Item ID: D117-762-011 Accept *N900040100* Setup Start *NS1*
Revision ID: Stop *NS2*
Item Name: Skidtube with Standard Wearplates Fits LH or RH

DART SERVICE INSTRUCTION

TO AMEND INSTALLATION INSTRUCTIONS IIN-D117-762 REV. E AND
INSTRUCTIONS FOR CONTINUED AIRWORTHINESS ICA-D117-762 REV. 4

A	NEW ISSUE	RF	17.01.09
REV.	DESCRIPTION	BY	DATE
DESIGN	RF	DART AEROSPACE, LTD EUGENE, OR	
DRAWN	RF		
CHECKED	WK	DRAWING NO.	REV.A
MFG. APPR.	N/A	DSI 9771	SHEET 1 OF 2
APPROVED	HS	TITLE	SCALE
DE APPR.		GHL UPGRADE KIT	NTS
DATE	17.01.09	COPYRIGHT ©2017 BY DART AEROSPACE USA, INC THIS DOCUMENT IS PRIVATE AND CONFIDENTIAL AND IS SUPPLIED ON THE EXPRESS CONDITION THAT IT IS NOT TO BE USED FOR ANY PURPOSE OR COPIED OR COMMUNICATED TO ANY OTHER PERSON WITHOUT WRITTEN PERMISSION FROM DART AEROSPACE, LTD.

FIGURE 1 - GHL UPGRADE INSTALLATION

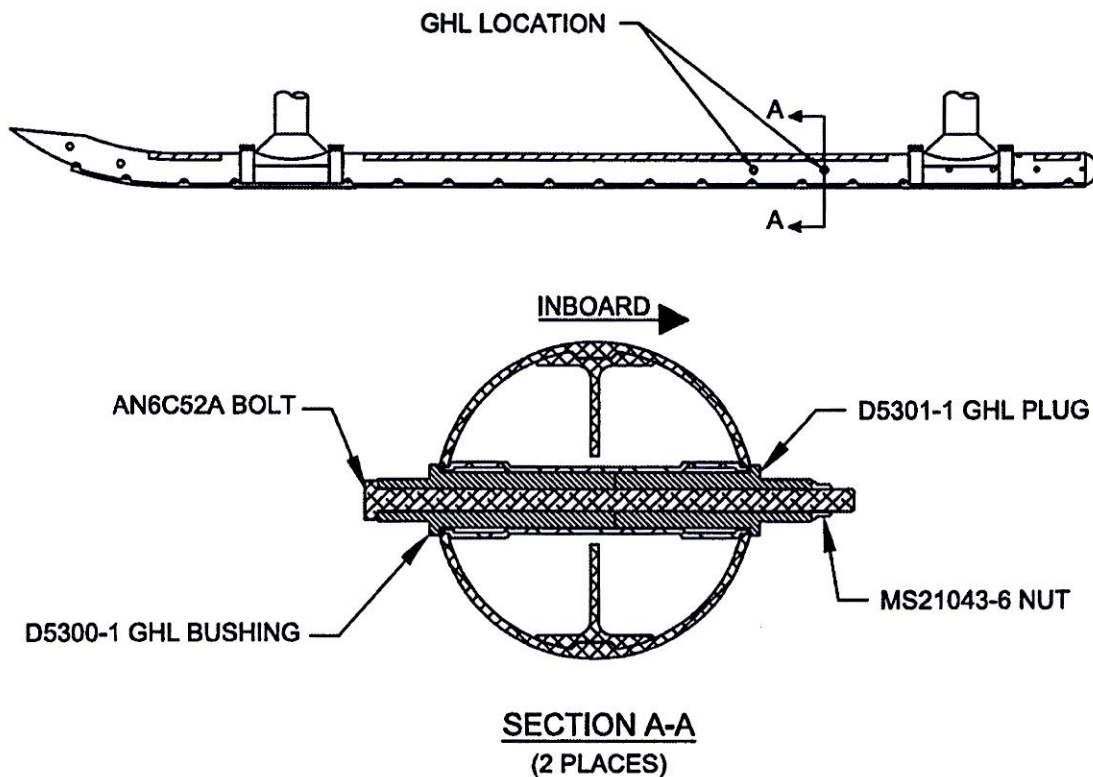
The purpose of this Dart Service Instruction (DSI) is to replace the ground handling lugs (D3864-1 Bushings, AN6C51A Bolts and MS21043-6 Nuts) on the D117-762-XXX Skid tubes with a structurally superior lug design (D5300-1 Bushings, D5301-1 Plugs, AN6C52A Bolts, MS21043-6 Nuts) as shown in Figure 1. The new hardware will be included in D117-762-011 @ CHG 004 and subsequent.

- 2.1 Loosely install (qty 2) D5300-1 GHL Bushing & (qty 2) D5301-1 GHL Plug wet with Proseal 890 or MIL-S-8802 Class B2 Sealant in location shown in Figure 1.
- 2.2 Install (qty 2) AN6C52A Bolts and (qty 2) MS21043-6 Nuts in accordance with Figure 1. Clean up squeezed out Proseal and apply fillet seal around D5300-1 & D5301-1.
- 2.3 Torque AN6C52A Bolts 160 - 190 in-lbs (18.1 - 21.5 N-m).

ITEM	QTY -011	PART NUMBER	DESCRIPTION
	X	D117-762-011	SKIDTUBE INSTALLATION
50	2	AN6C52A	BOLT
51A	2	D5300-1	GHL BUSHING
51B	2	D5301-1	GHL PLUG
52	2	MS21043-6	NUT

ITEM	QTY -011	PART NUMBER	DESCRIPTION
	X	D117-762-011	SKIDTUBE INSTALLATION
50	2	AN6C51A	BOLT
51	4	D3864-1	BUSHING
52	2	MS21043-6	NUT
